A585 Windy Harbour to Skippool Improvement Scheme

7.11 Environmental Statement Changes and Corrections Document

Environmental Statement Changes and Corrections Document

Version	Date	Status of Version
Rev 0	May 2019	Deadline 2 Submission
Rev 1	July 2019	Deadline 4 Submission

Rev	Status	Rev. Date	Purpose of revision	Drawn	Chk'd	Appr'd
1	SS	MAY19	S8 - DEADLINE 2 SUBMISSION	JN	KB	NH
0	SS	OCT18	S8 - DCO SUBMISSION	JN	KB	NH

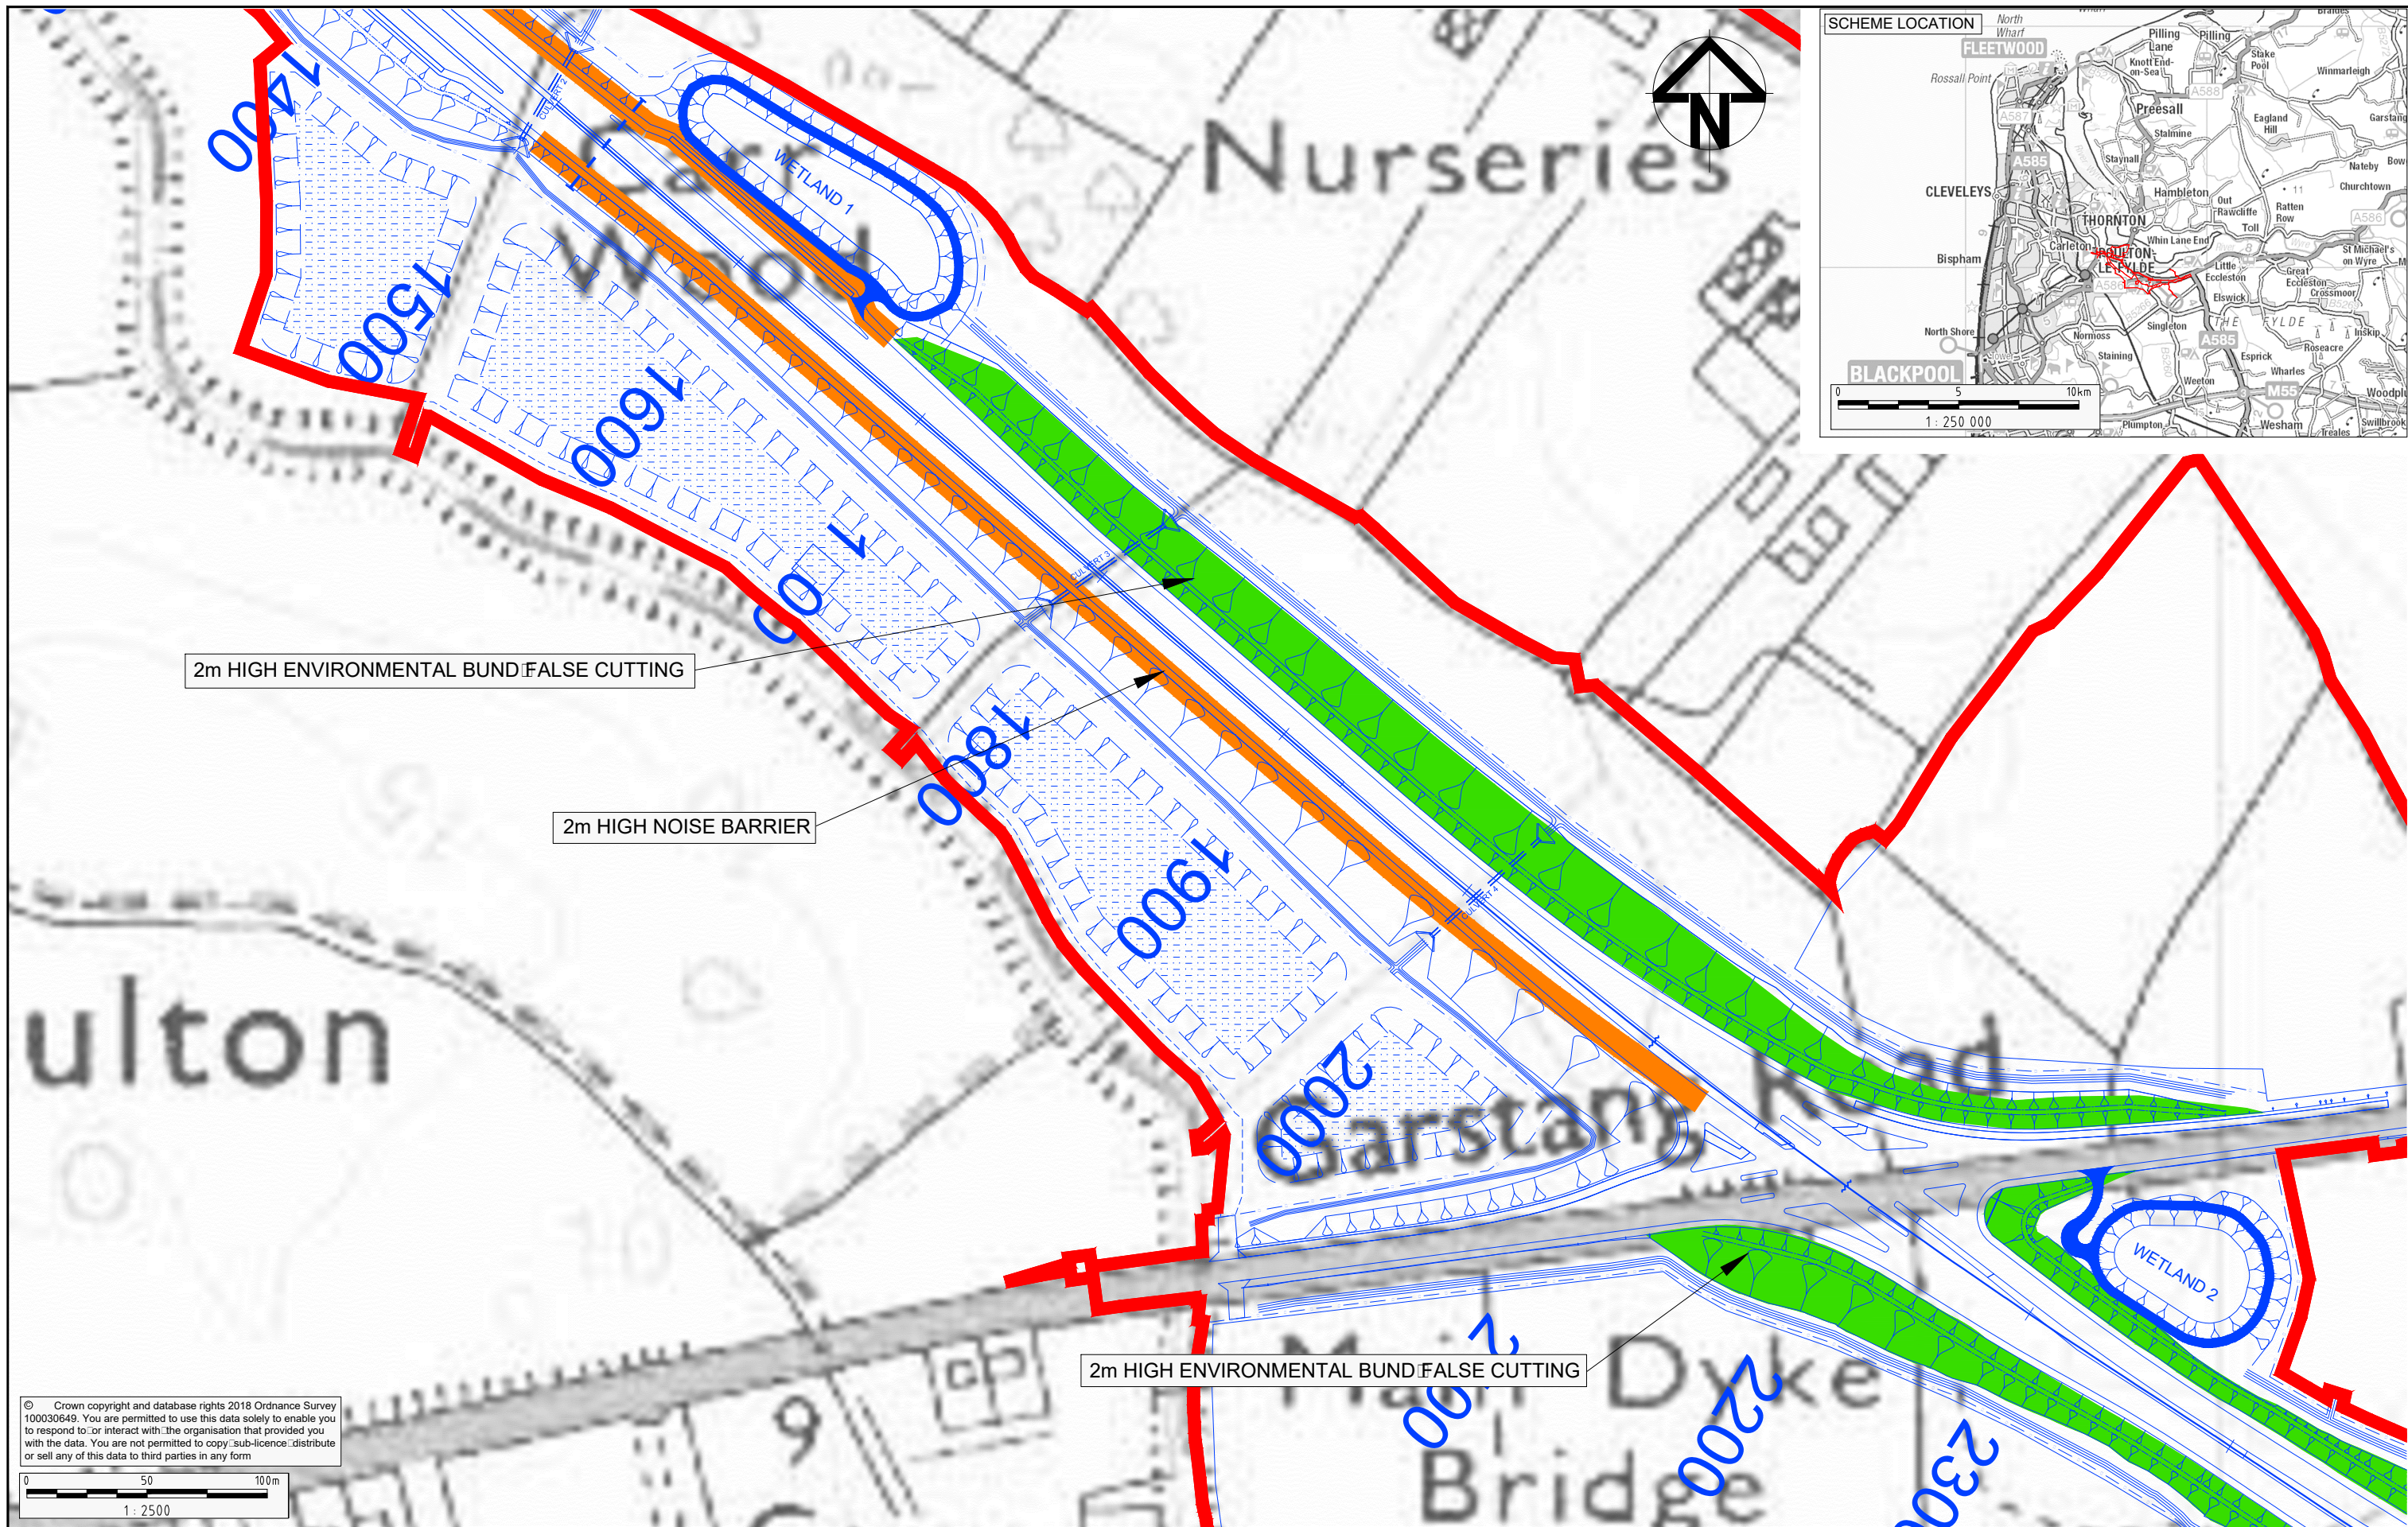
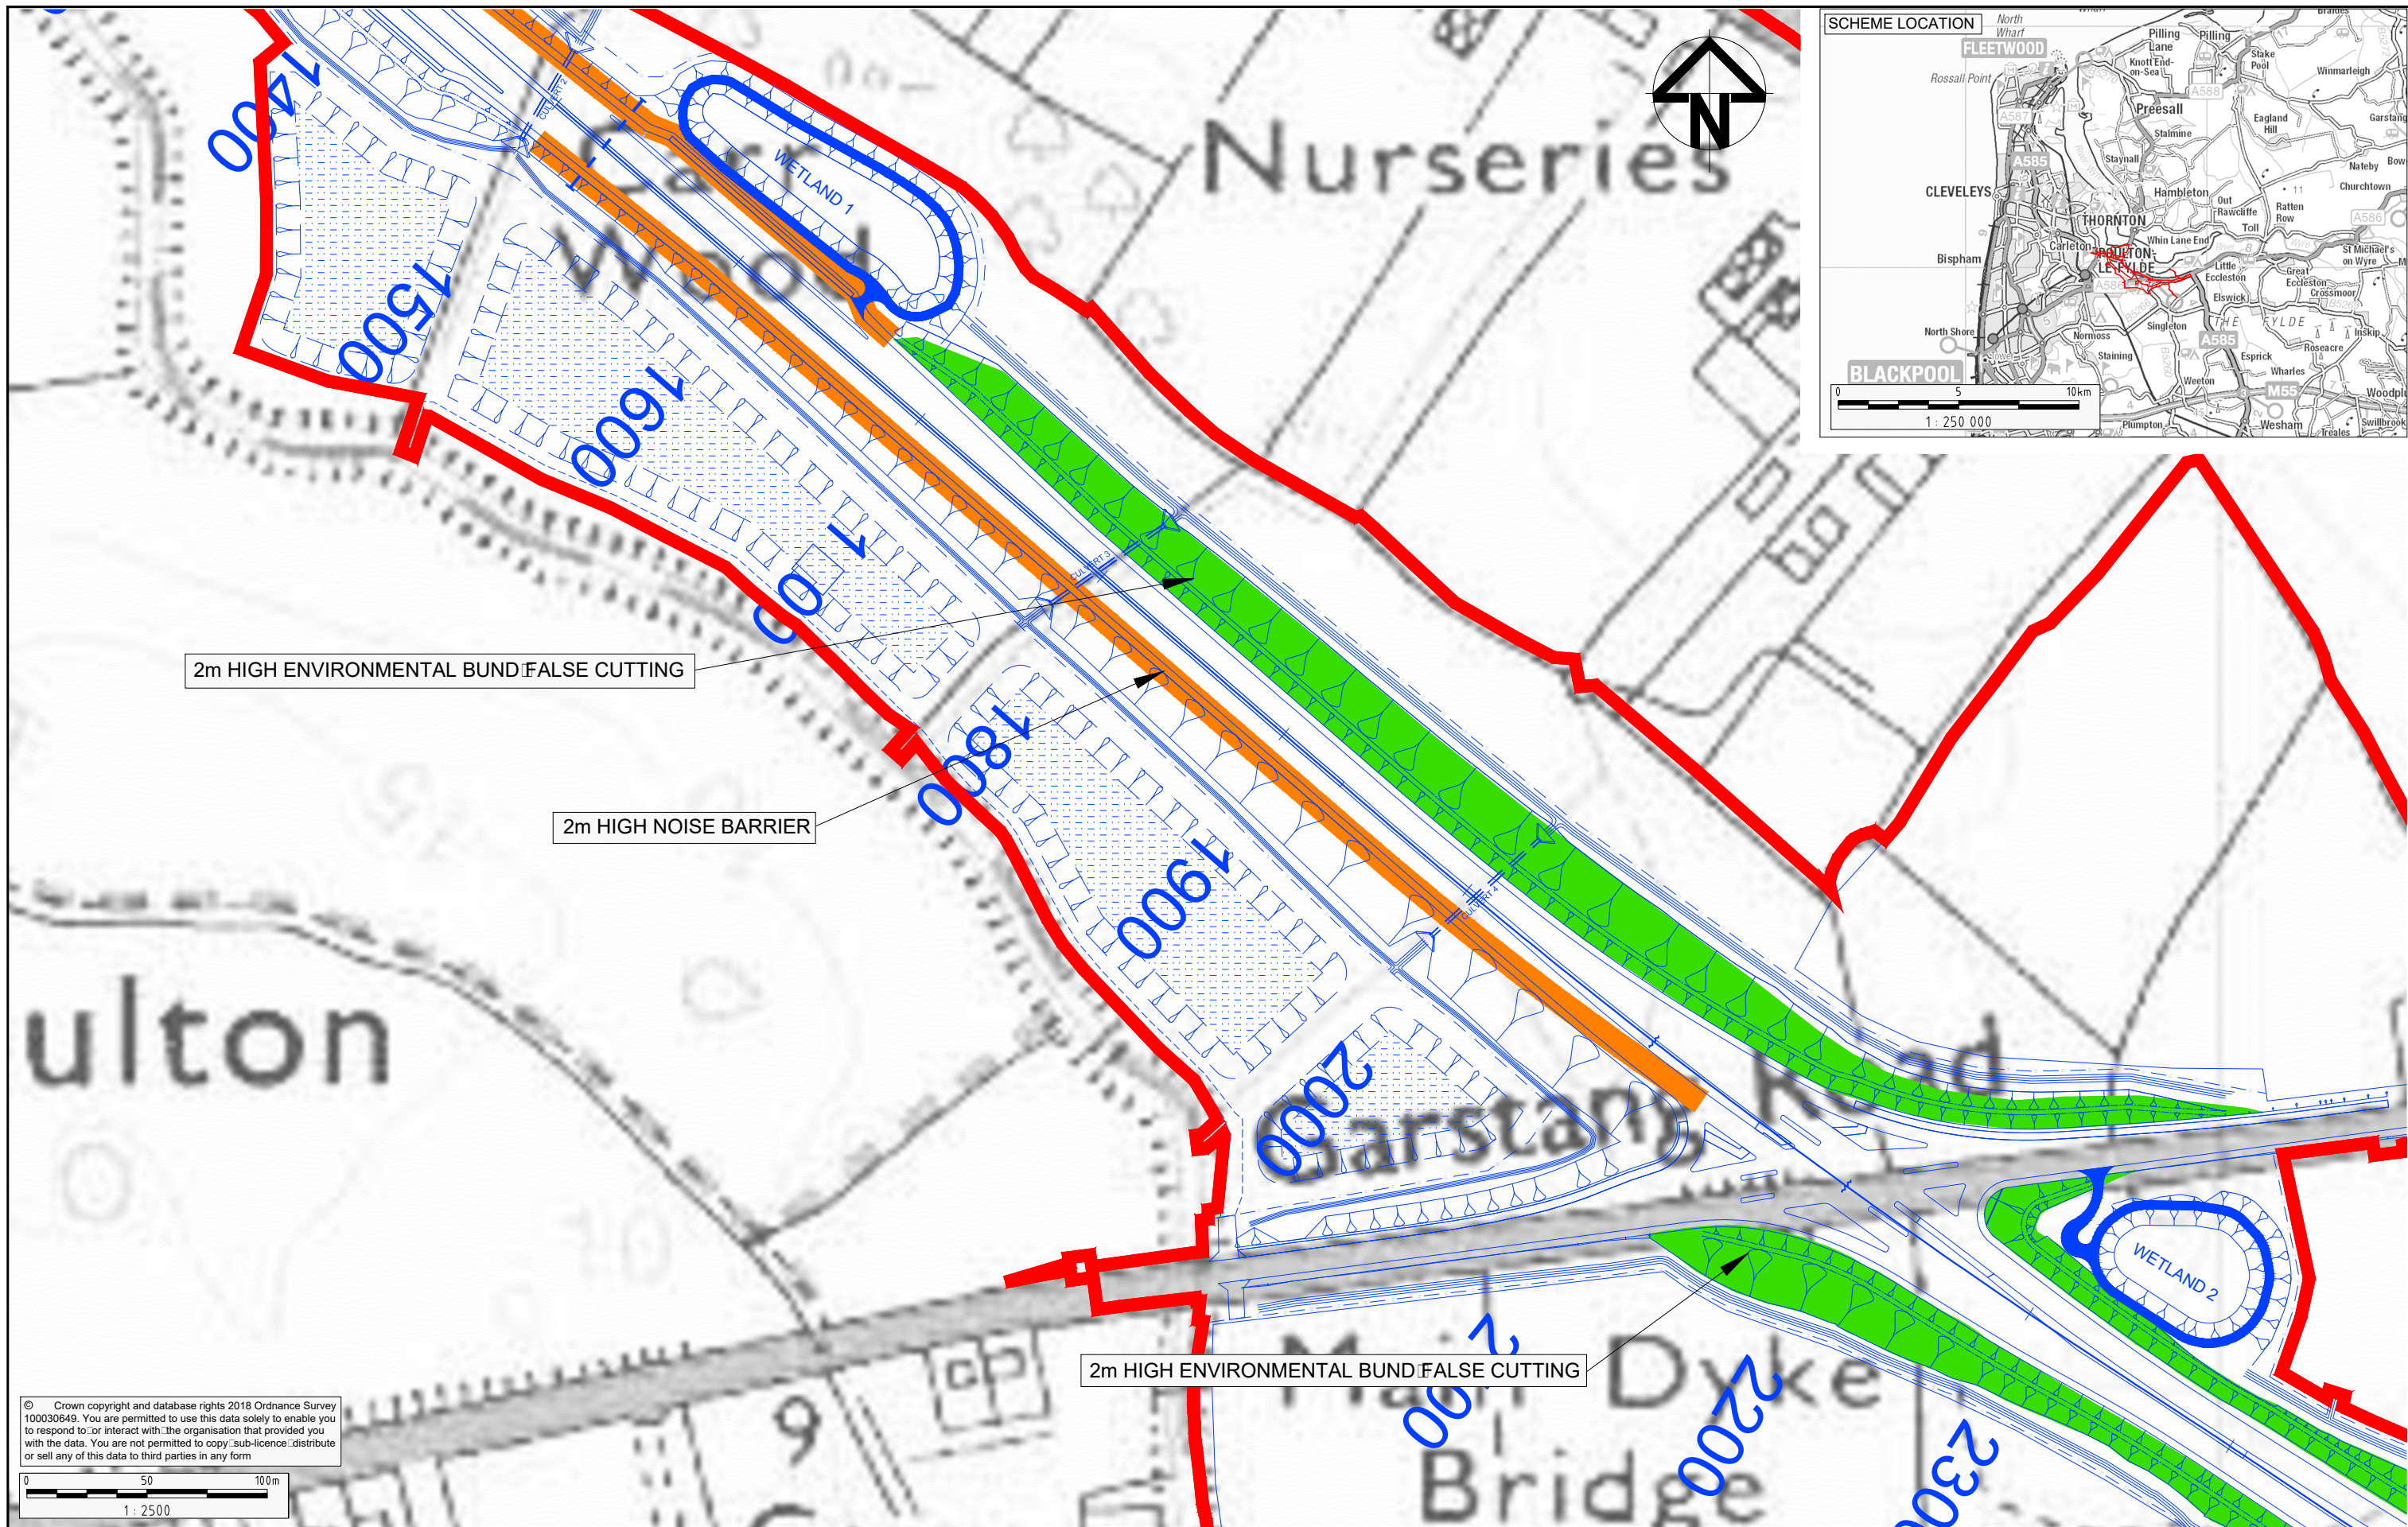
Document Reference Number	Document Name	Amendment Required	Reason
			TR010035/APP/7.10).
6.11	ES Chapter 11: Noise and Vibration	Update to Figure 11.4: Noise and Vibration – Noise Mitigation within the Study Area presented at Appendix D to show heights and locations of earth mounds and acoustic fencing at a larger scale.	Requested by the Inspector within the first round of written questions (document reference TR010035/APP/7.10).
